## SERVICE BULLETIN

ENGINE - FUEL AND CONTROL - TO PROVIDE A NEW ELECTRONIC ENGINE CONTROL (EEC) WITH THE  
D5 SCN13/N SOFTWARE CONFIGURATION - CATEGORY CODE 4 - MOD.ENG-73-0129

# V2500-ENG-73-0129

Location of the Electronic Engine Control (EEC)  
Fig.1

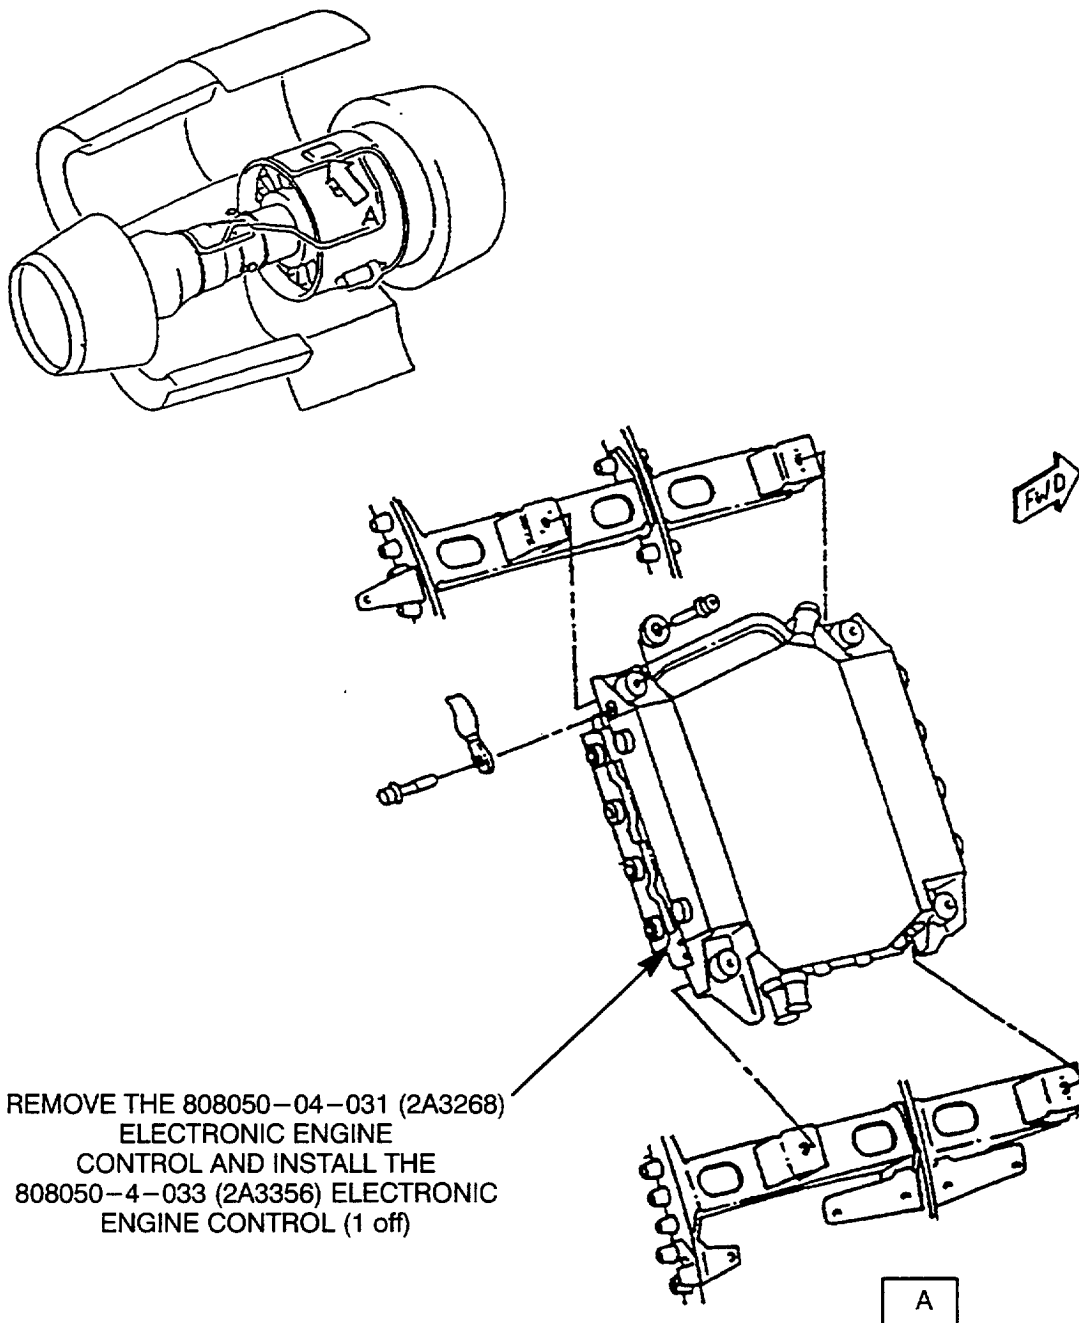
- (1) Remove the 808050-4-031 (2A3268) Electronic Engine Control by the procedure given in Reference (3), Chapter/Section 73-21-34, Removal Installation. Refer to Figure 1.

See Figure 1.

- (1) Install the 808050-4-033 (2A3356), Electronic Engine Control (1 off) by the approved procedure given in Reference (3), Chapter/Section 73-21-34, Removal/Installation.

Family Tree - Electronic Engine Control (EEC) Ref. Catalog Sequence No. 73-22-34. Fig.  
01 Item 280  
Fig.2

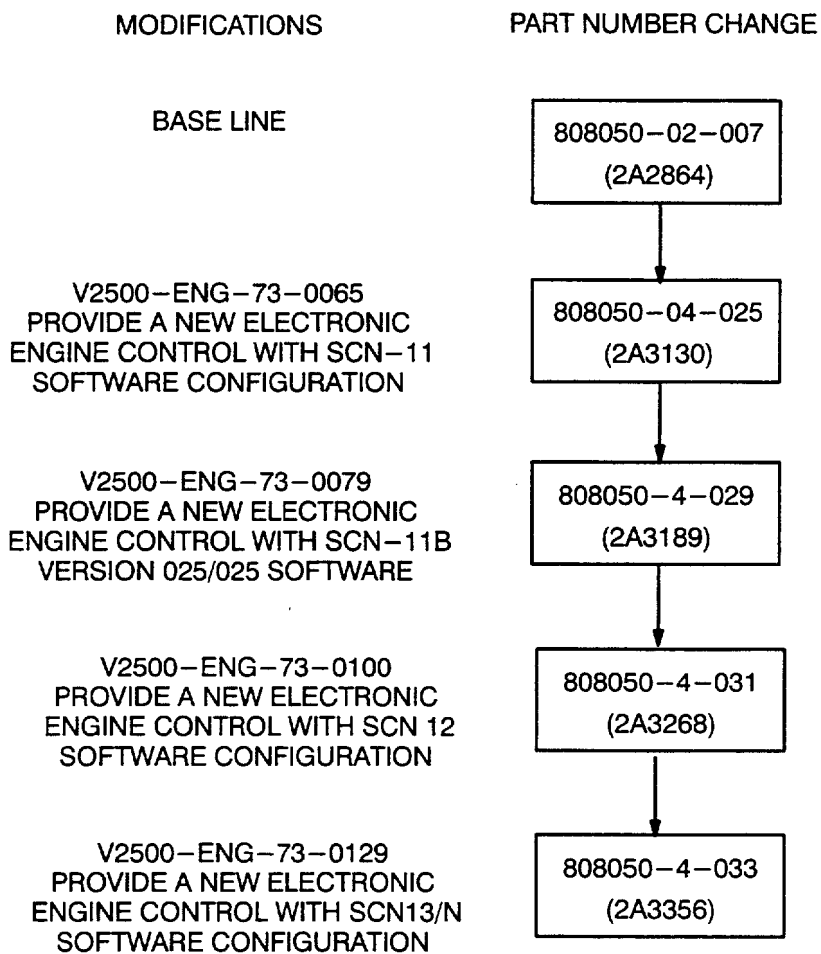
808050-4-033 1 (2A3356) (73-21-34)		Control, Electronic Engine		808050-4-031 (1D)(A) (2A3268) (01-280)	
--	--	----------------------------------	--	--	--
